REQUEST FOR PROPOSALS: Analog to IP Classroom Phone Replacement for Horace W. Porter School Columbia, CT

Solicitation Number 2019-3

ADDENDUM No. 3

Picture 1

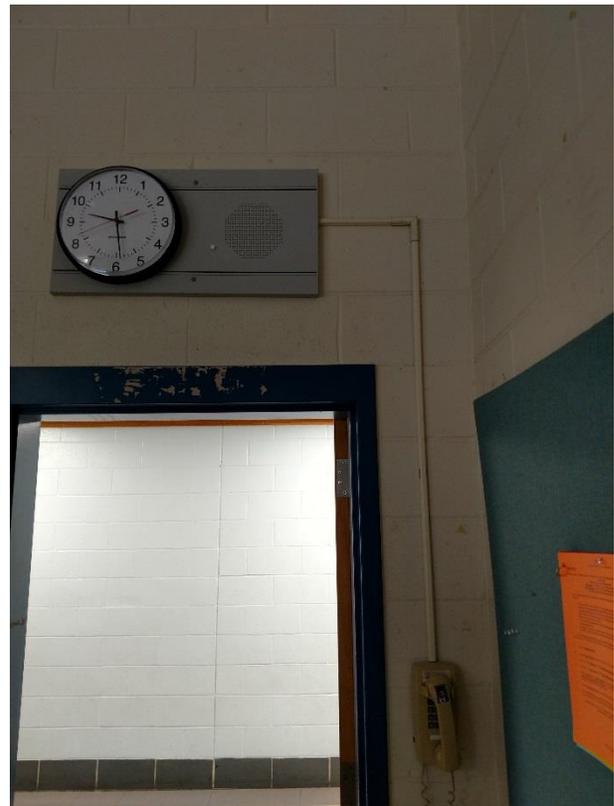
Q1. A request to have an additional walk through to clarify the placement of conduits and existing CAT 6 wiring terminations.

A1. It was determined that in room 605 that there was no conduit installed in the block, but there was enough room to pull the existing cable out through the hole in the block along with the new CAT 6 cable. (see picture below #1) This was the only room checked in that area, so the assumption is that they are all the same.
